REFERENCE: **B004-19 BPUB Remodel of the Existing Administration Building Restrooms Renovations Project**

## ADDENDUM NO. 01

**BPUB Restrooms Renovation Project**  
**BROWNSVILLE PUBLIC UTILITIES BOARD**  
ERO Project No.: 16002A

## **ADDENDUM 1 NARRATIVE**

##### **ITEM 1. Sheet MH101 – Mechanical Plan**

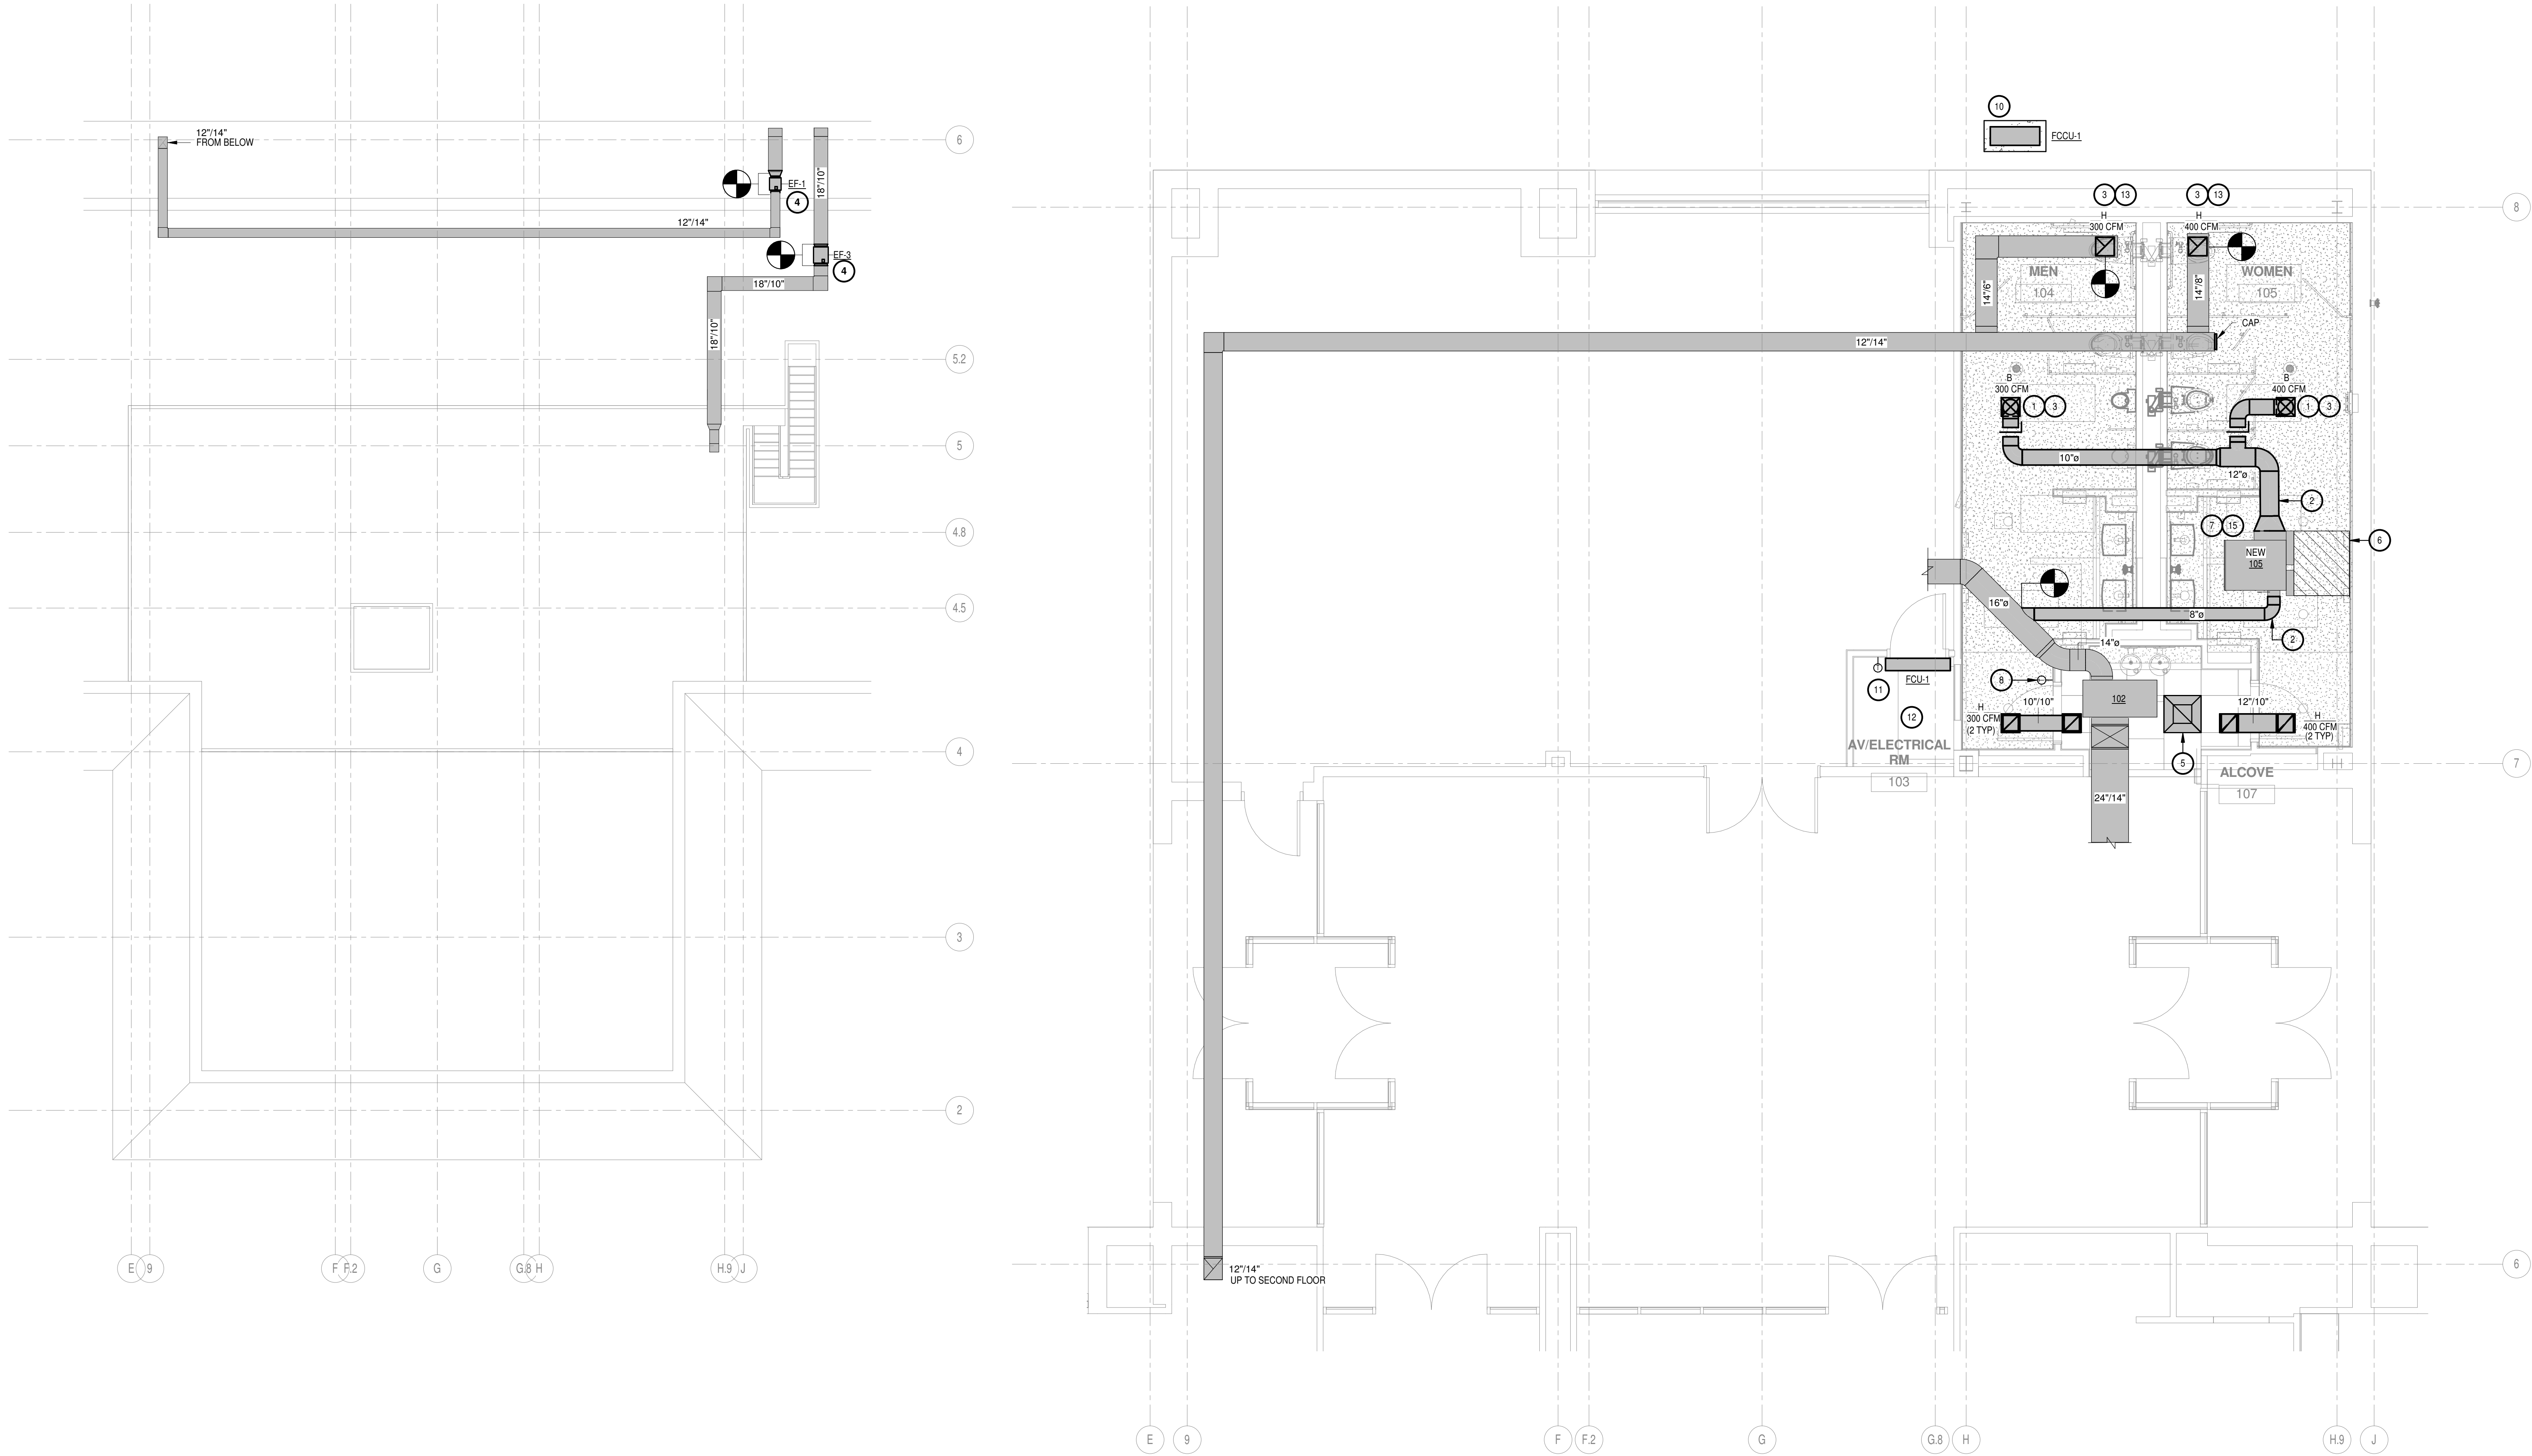
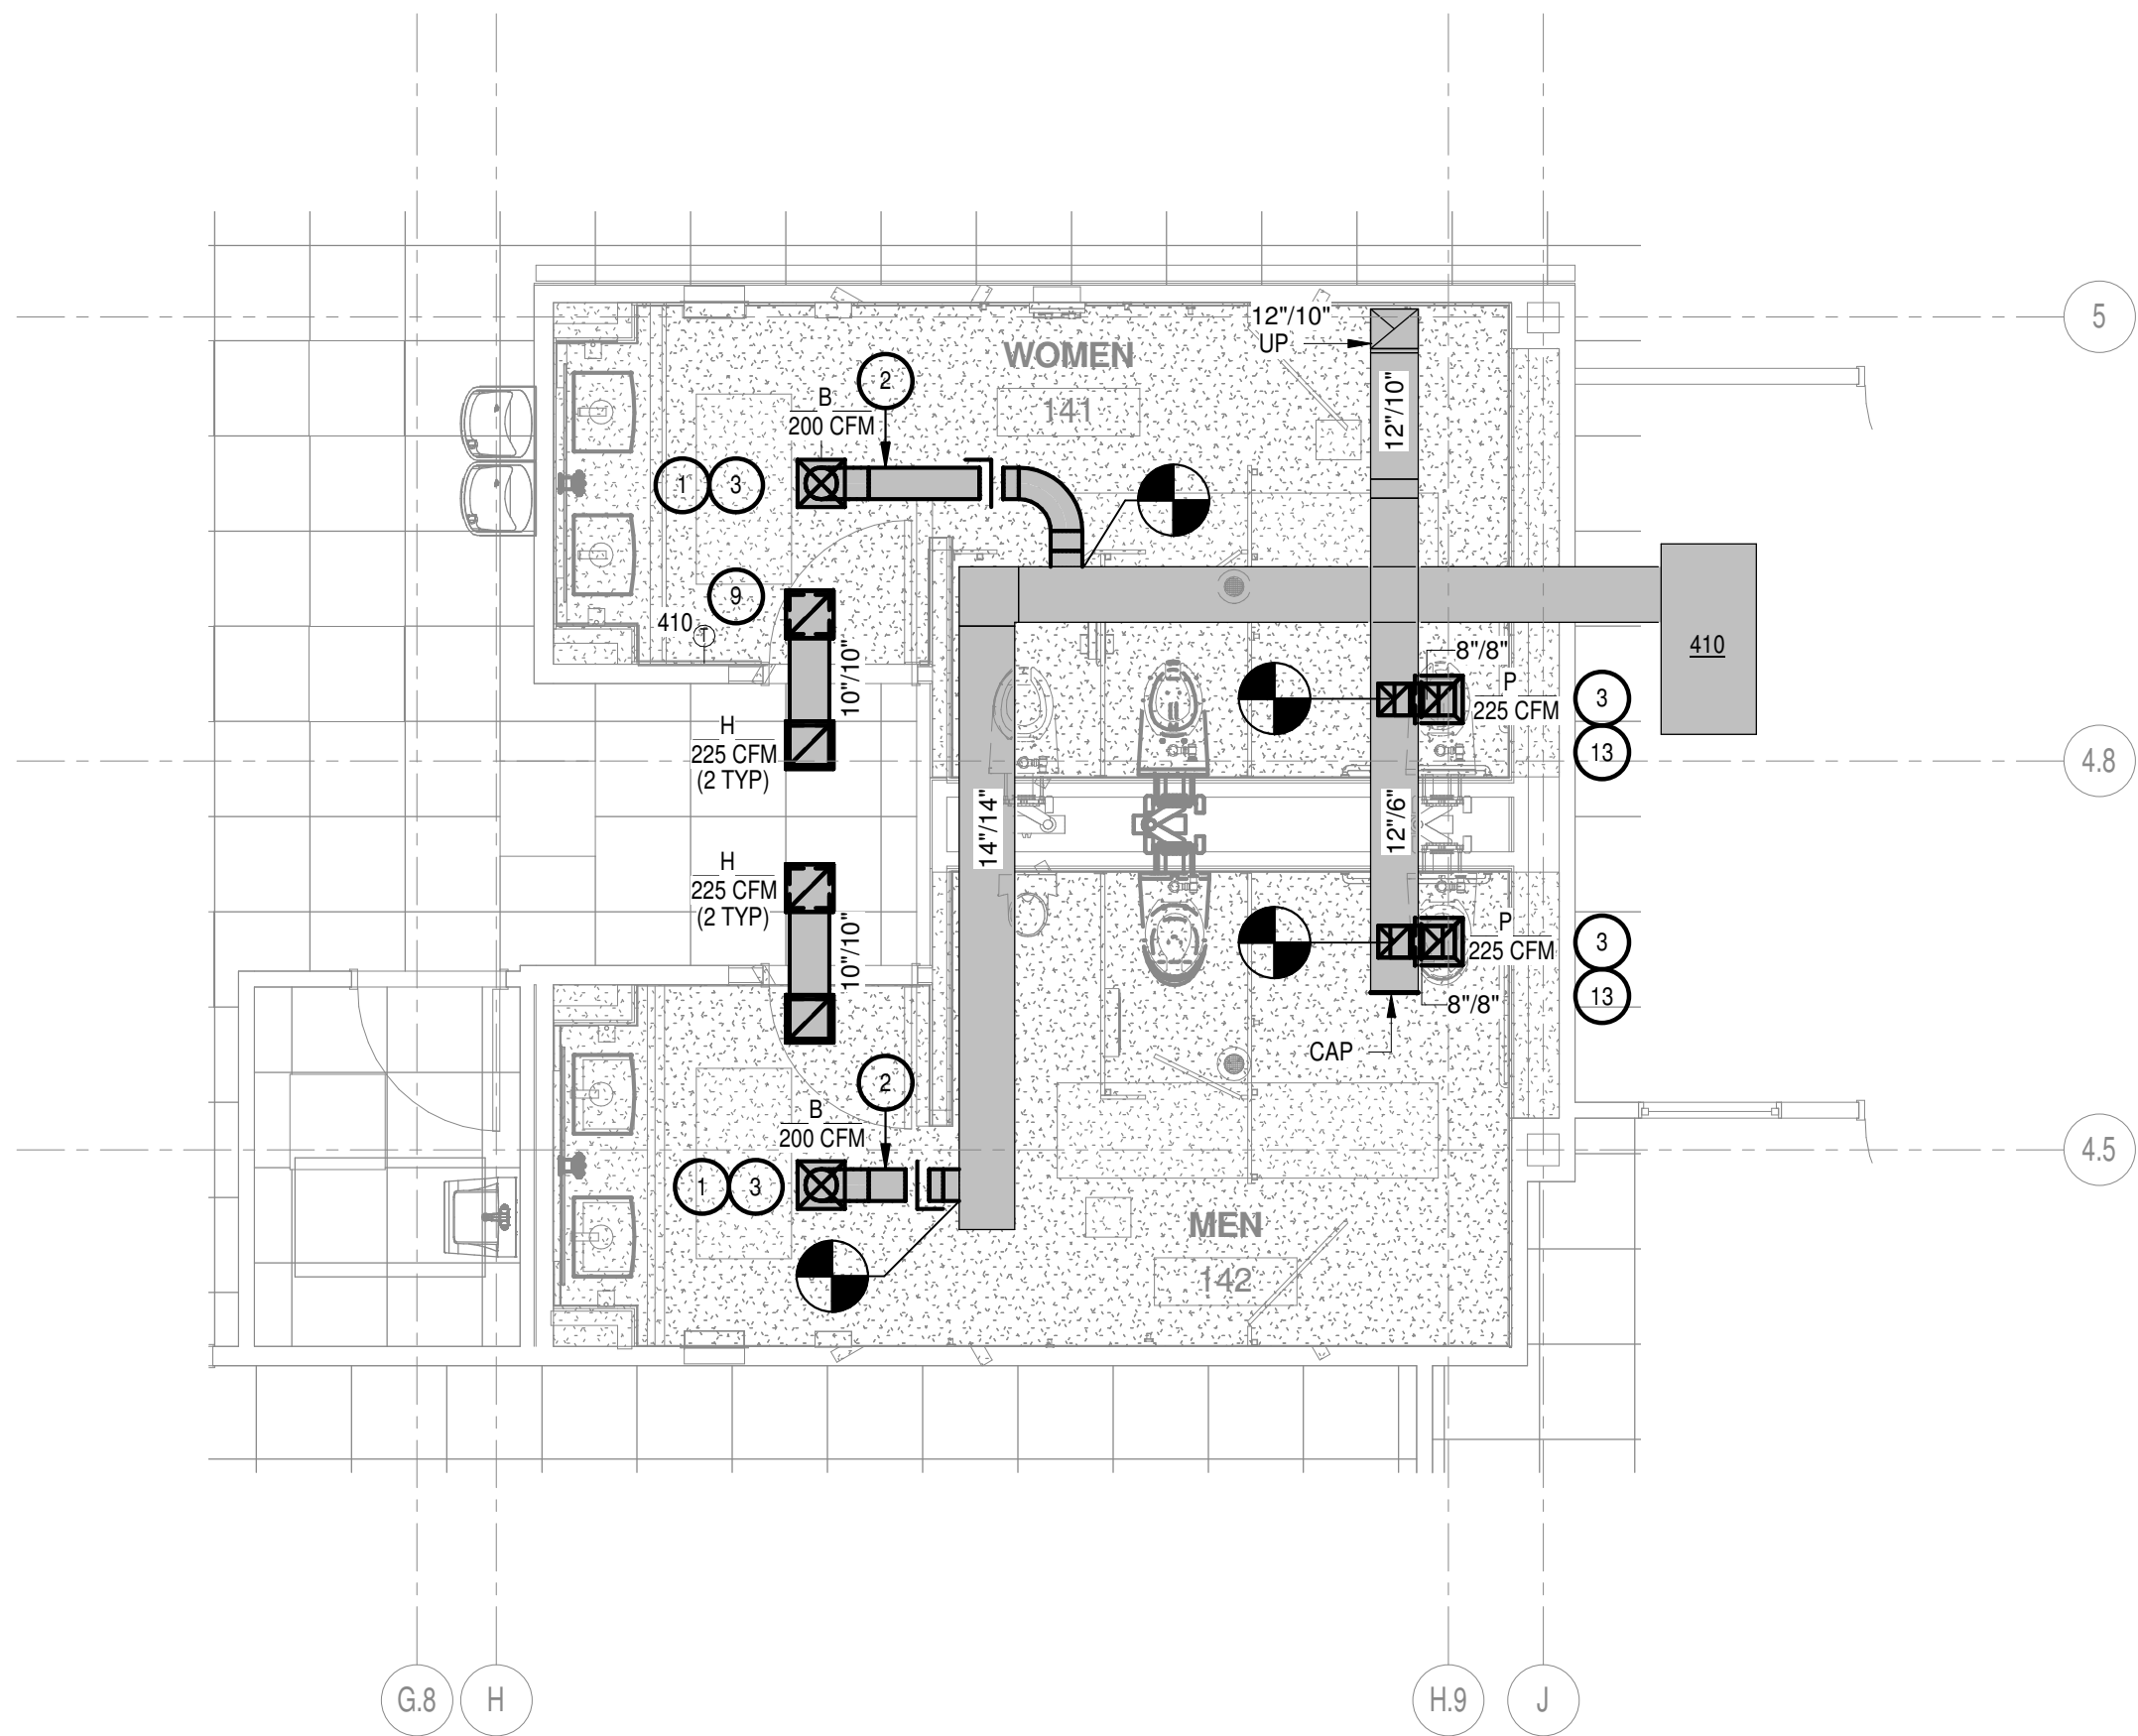
- a. Moved legend down to make key note 15 legible.
